Troy School District

**RFP #2425-09 - Addendum #1
BP#2B High School Athletics - Phase #2
January 21st, 2025**

Troy Schools District – RFP #2425-09 BP#2B High School Athletics Renovations - Phase #2

Addendum #1 Bidder Clarifications

C-6.0

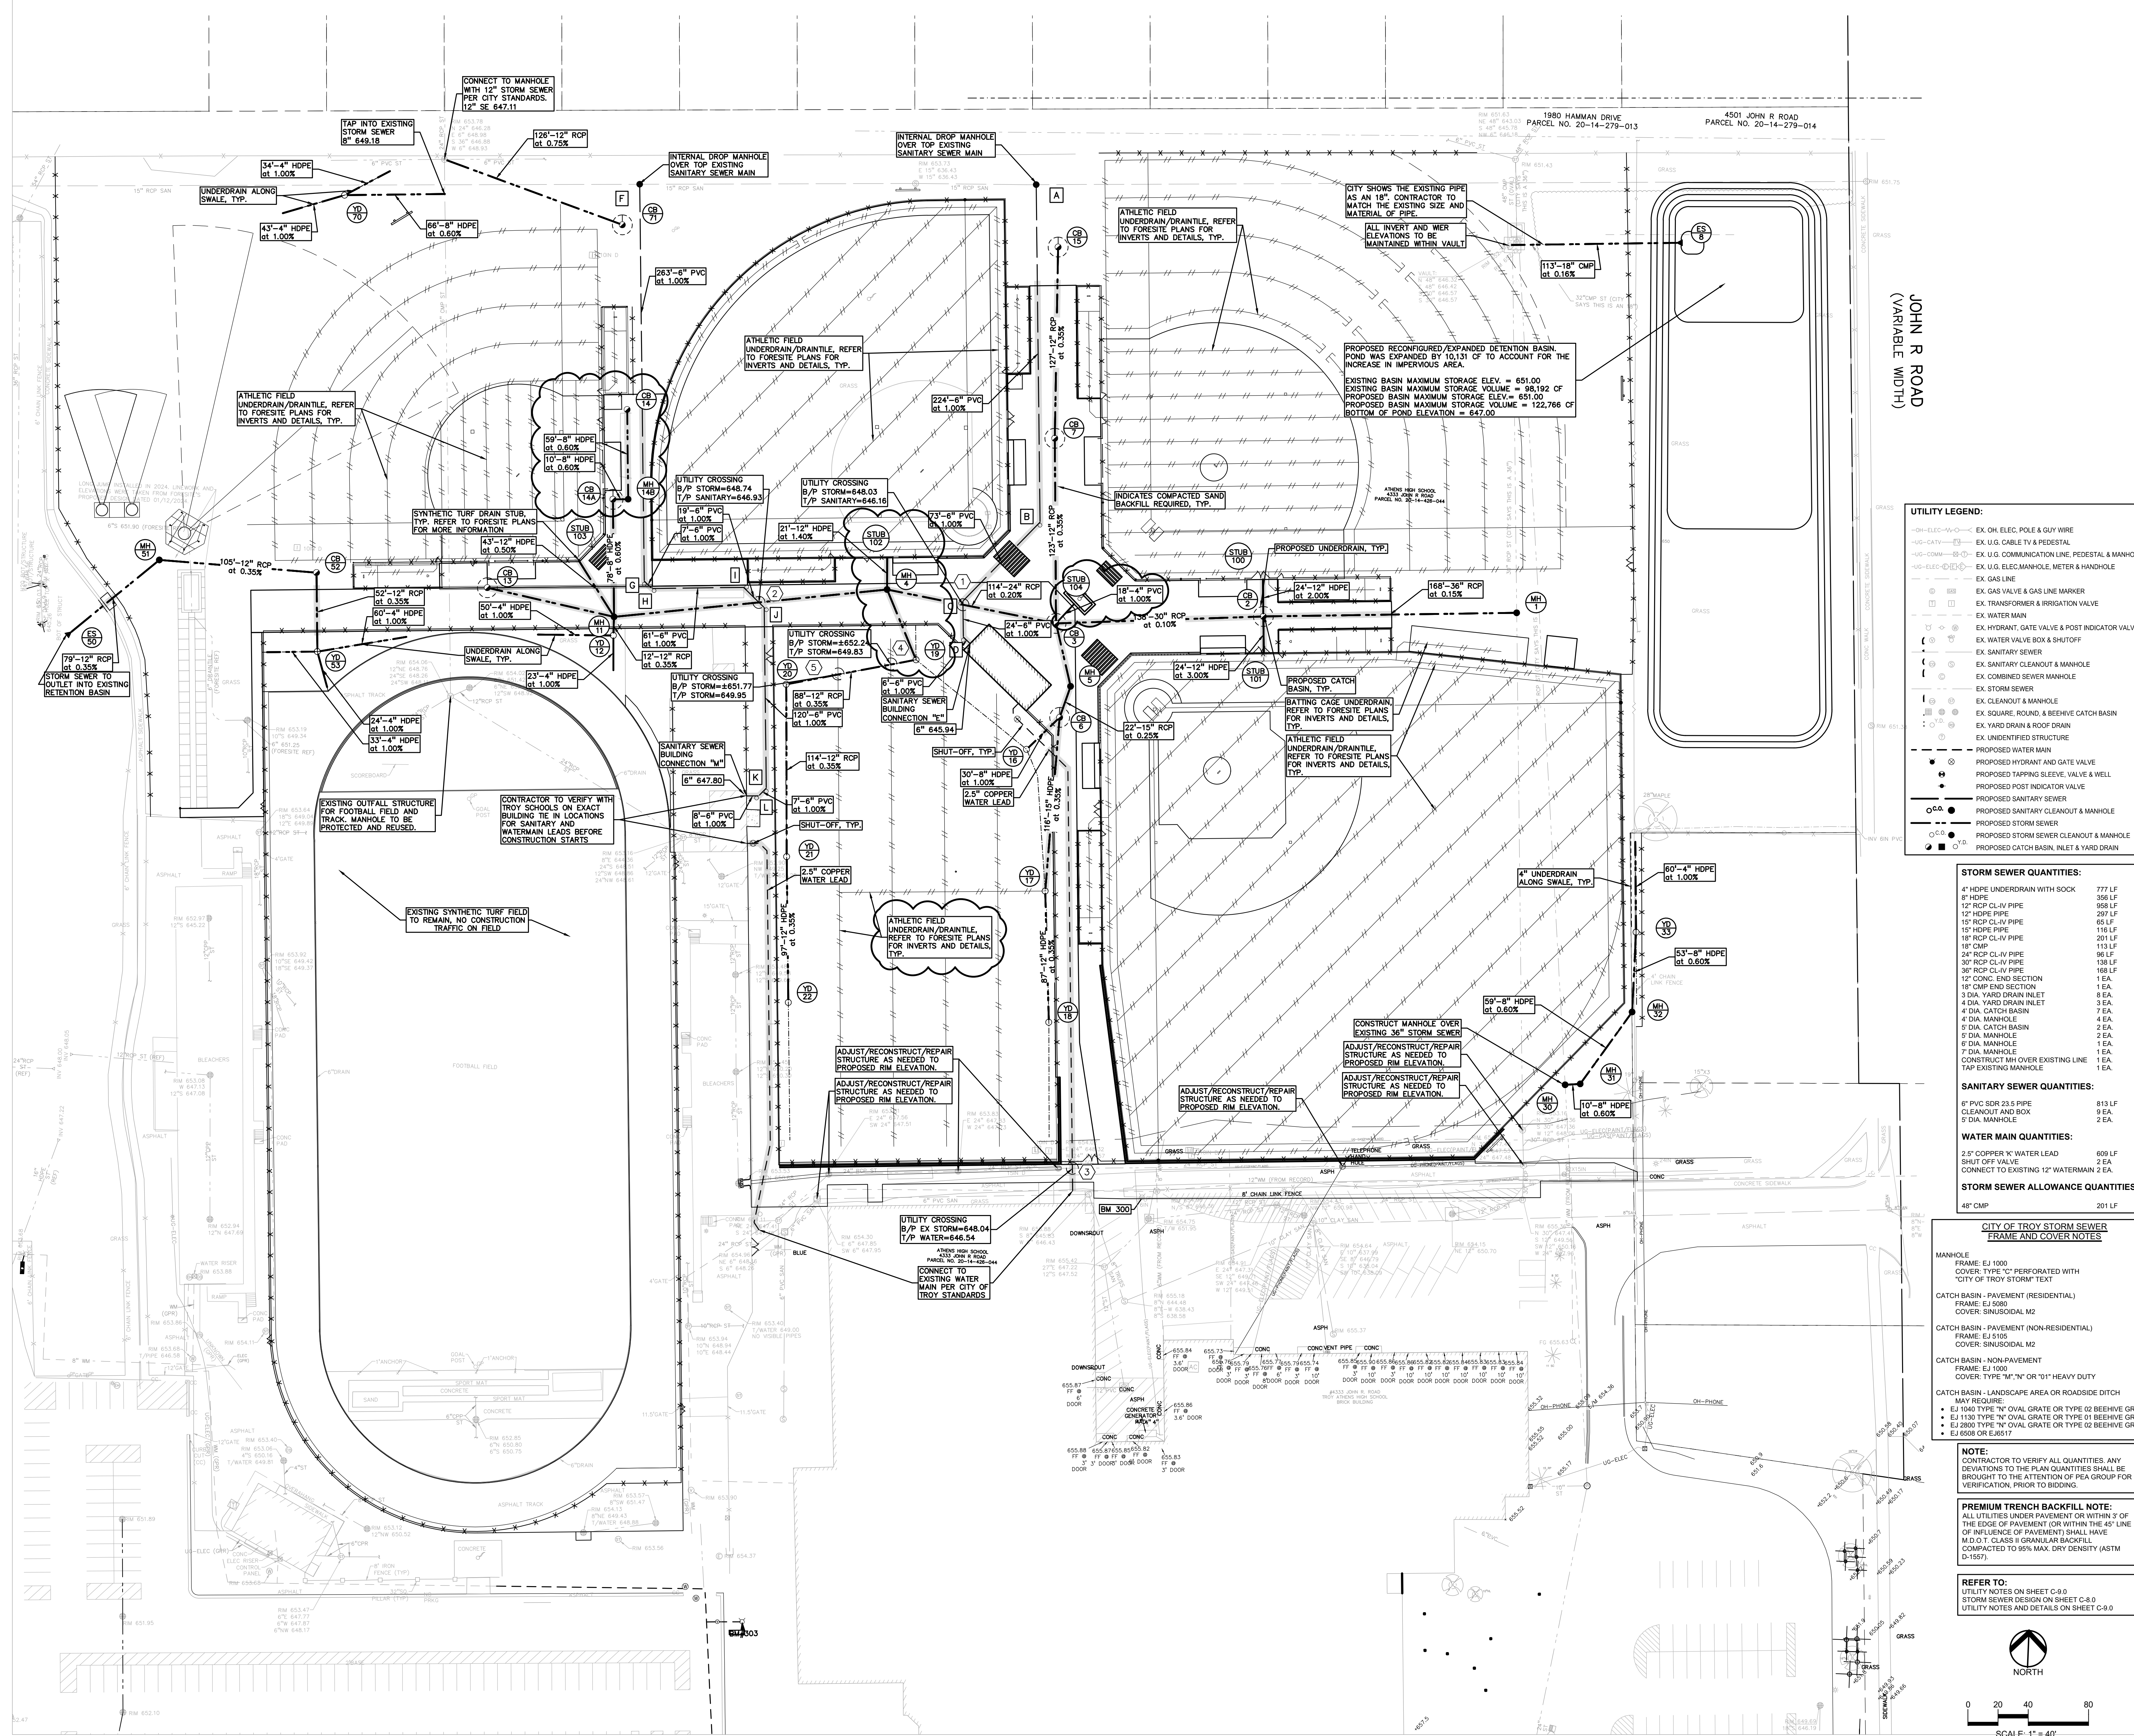
Q: Sheet C6.0 is showing an allowance for 48" CMP of 201 lineal feet and 48" end section of 1 – is this work part of base bid?

Q: Sheet C6.0 is showing an allowance for 48" CMP of 201 lineal feet and 48" end section of 1 – where is it located on the plans?

- A. Revised limits of earth disruption at the north end of the site as indicated.
- CD-8 Refer to Drawing No. C6.0 (reissued):
- A. Revised storm sewer piping around JV softball dugout (CB-14A to CB-14) as indicated.

- B. Revised storm sewer piping around MH-4 and location of STUB-102 as indicated.
 - C. Added note referencing underdrain in practice field as indicated.

- D. Added STUB-104 and piping from flagpole seat wall to CB-3 as indicated.
- CD-9 Refer to Drawing No. C6.1 (reissued):
- A. Revised storm structure table to reflect revised information as indicated.

A: Yes.

A: The contractor is to provide an "allowance" for the potential installation of the CMP. It may become necessary during construction.

C-7.0

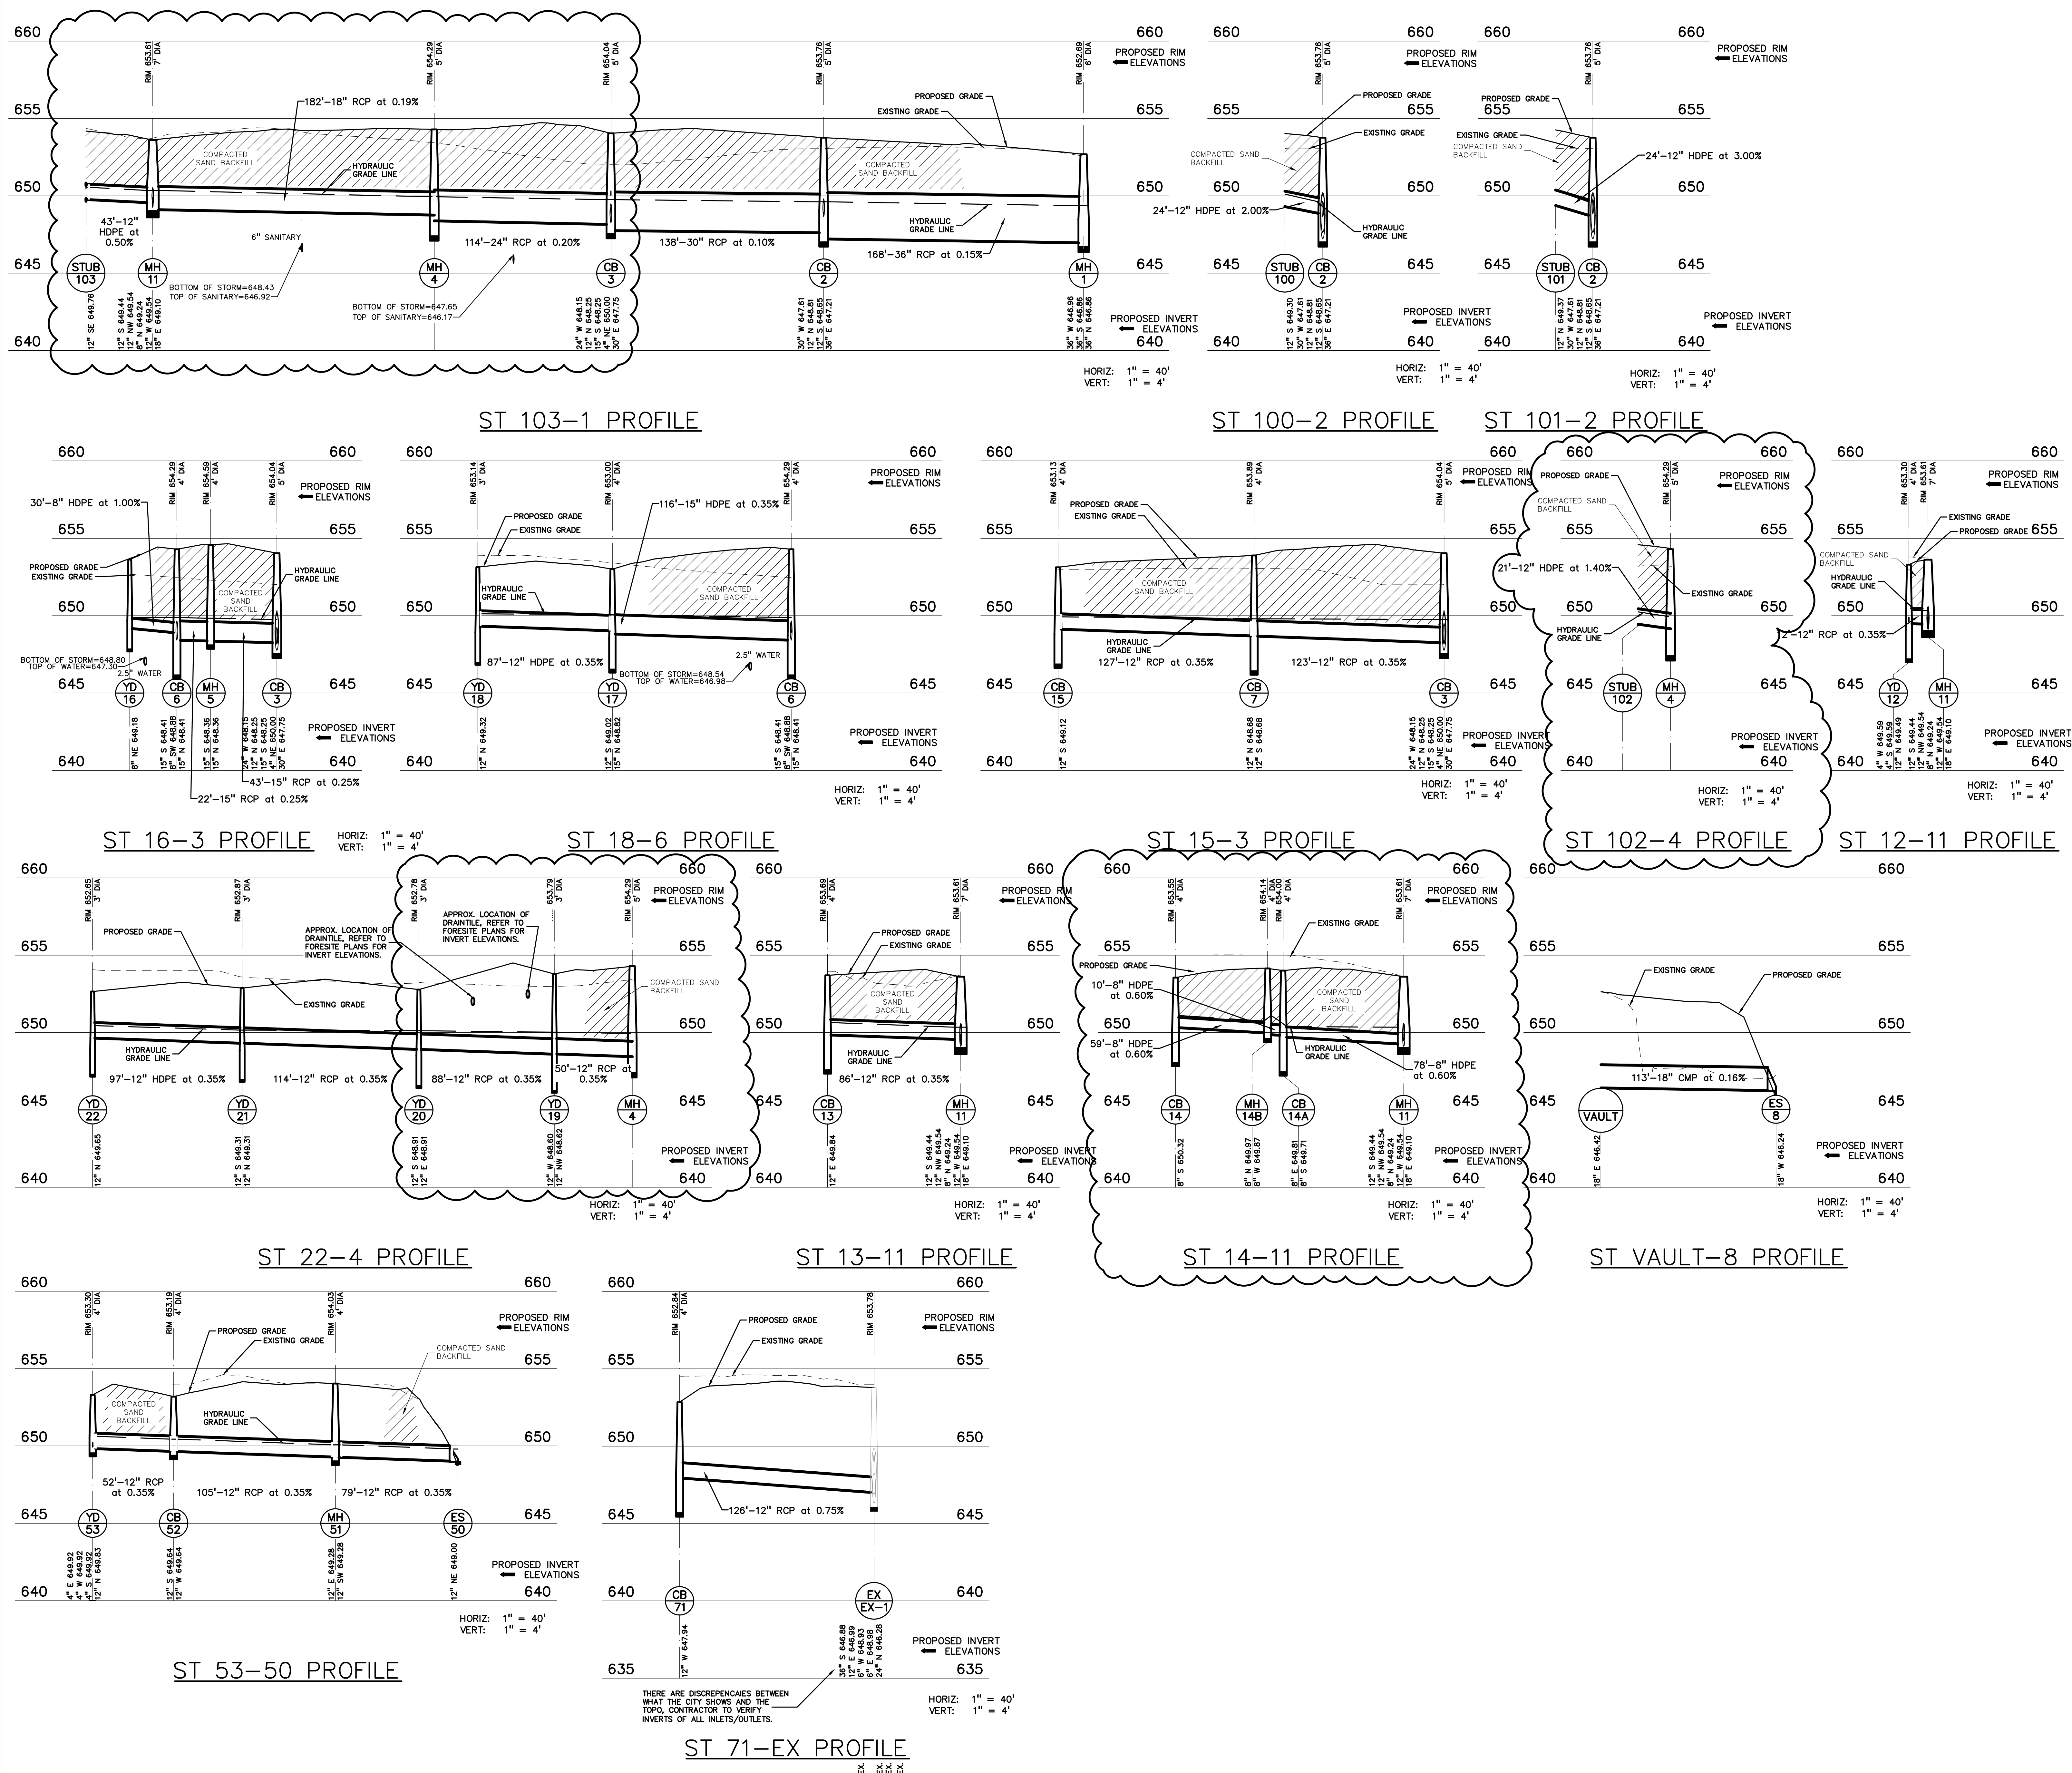
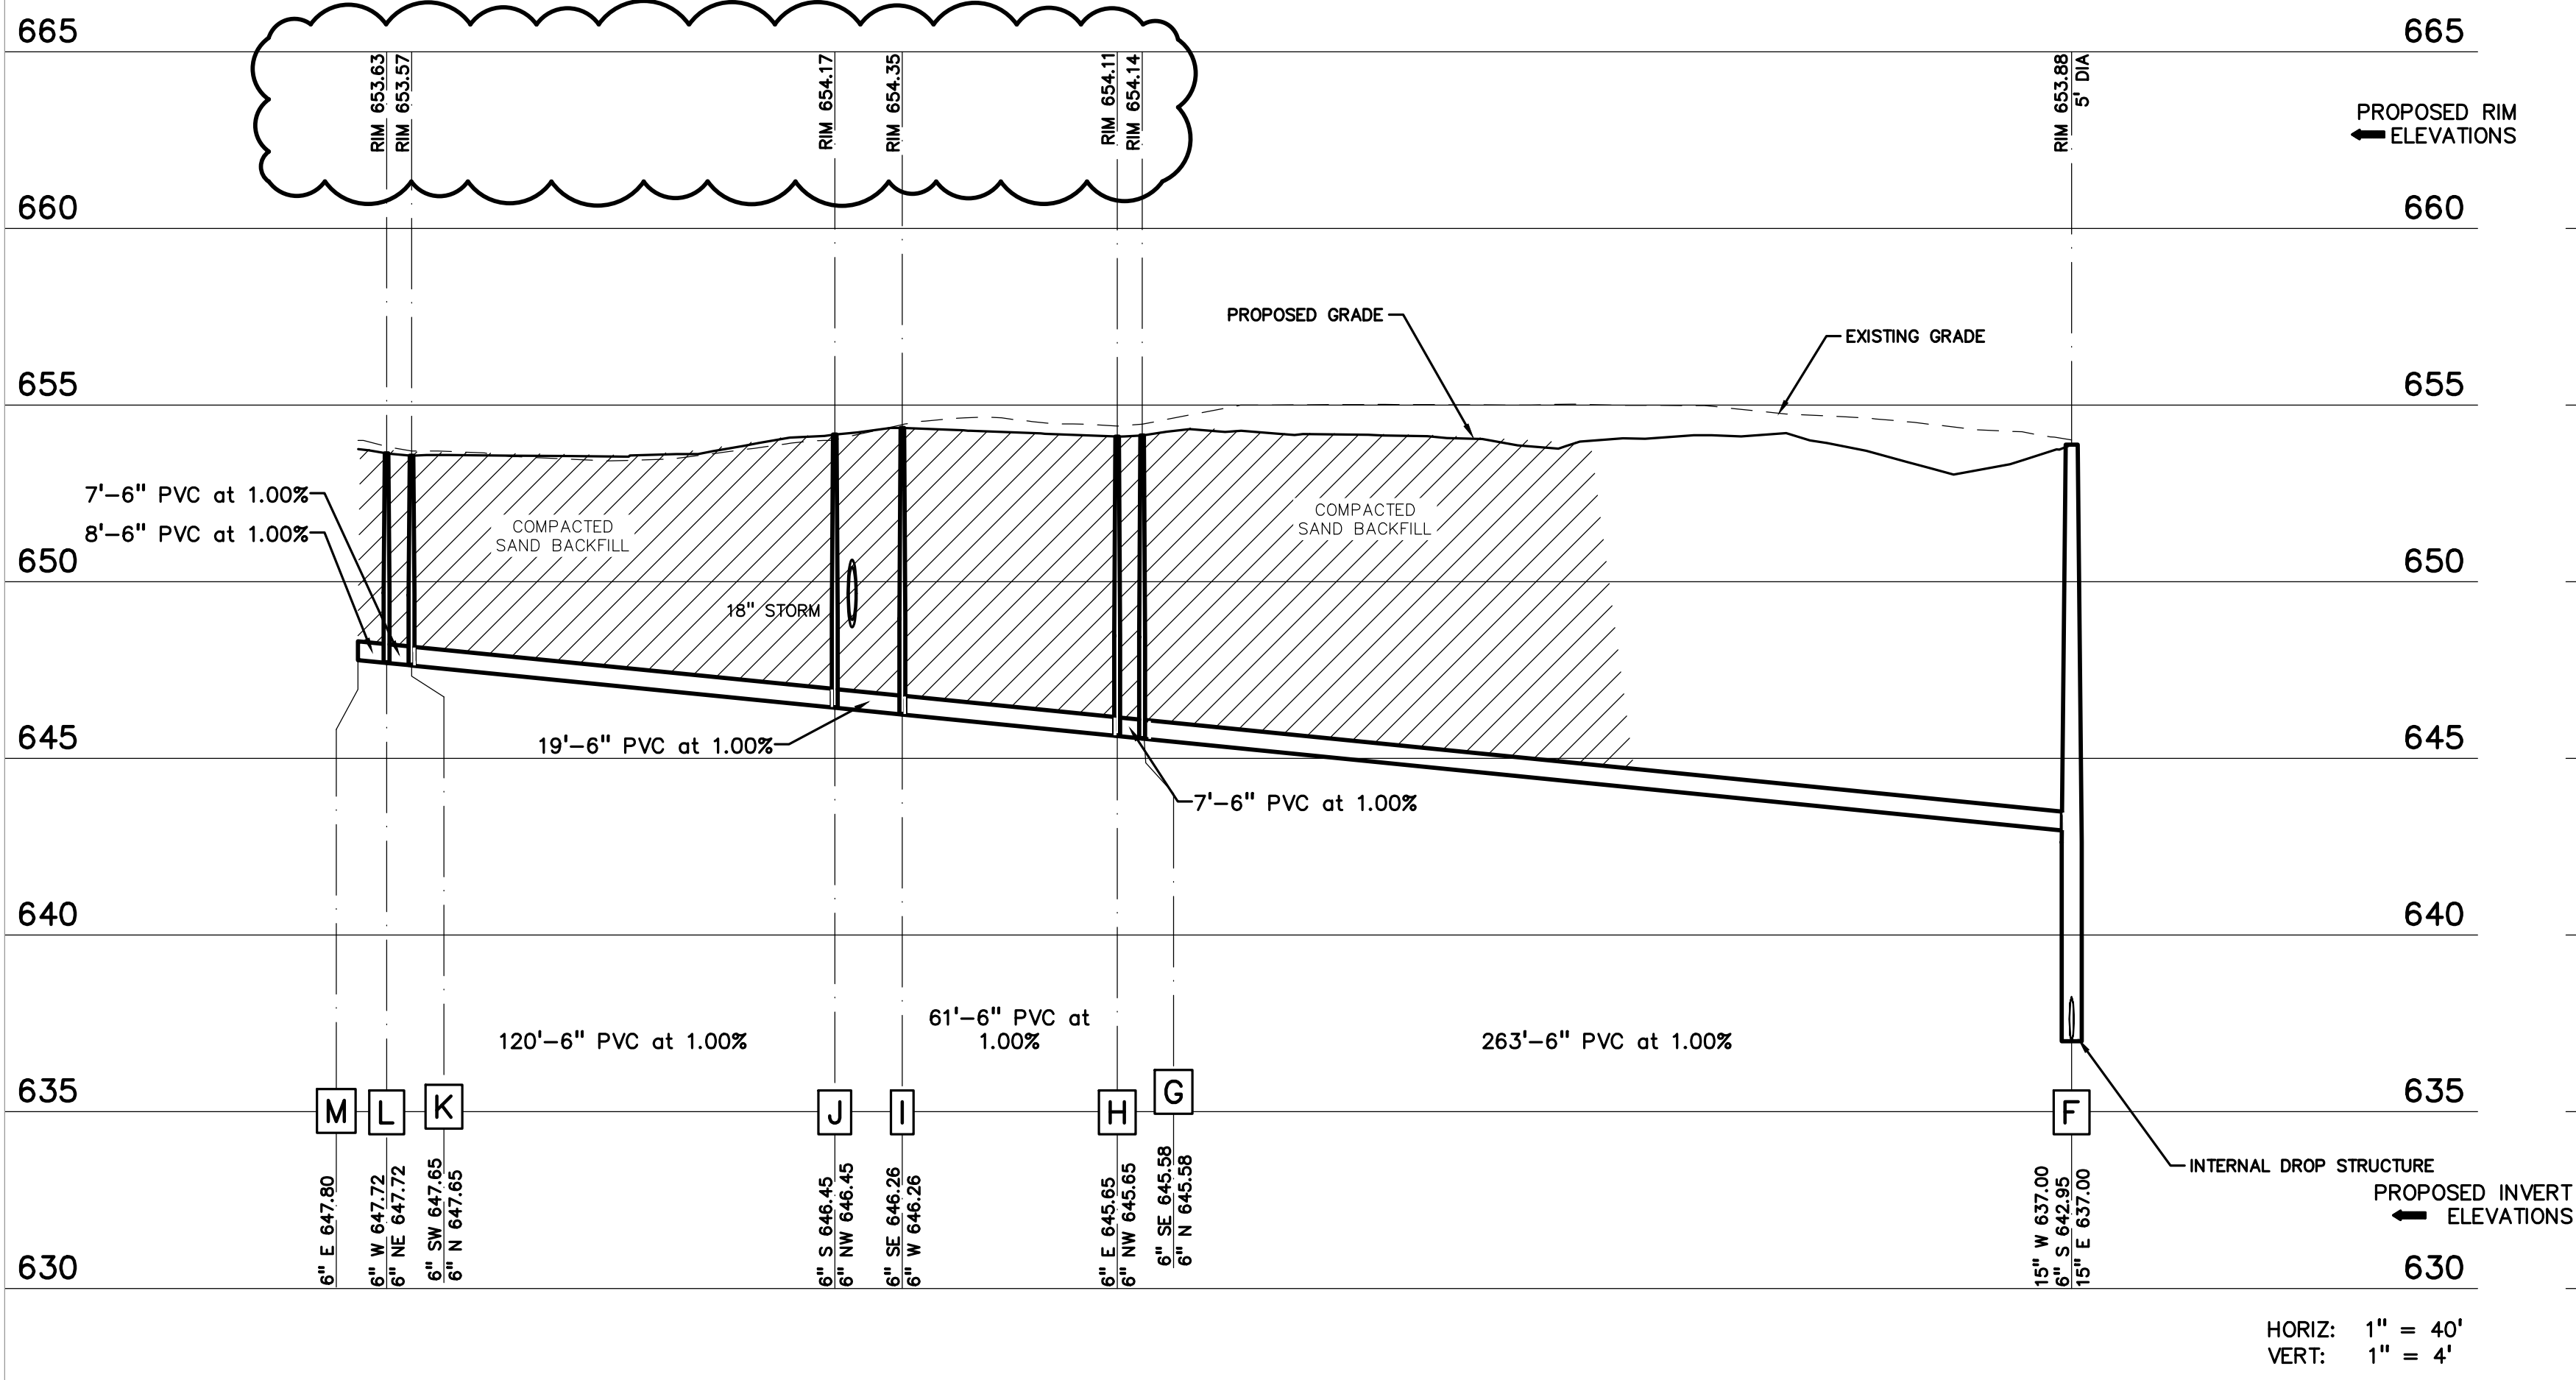
CD-10 Refer to Drawing No. C7.0 (reissued):
 A. Revised profiles to account for plan adjustments as indicated.
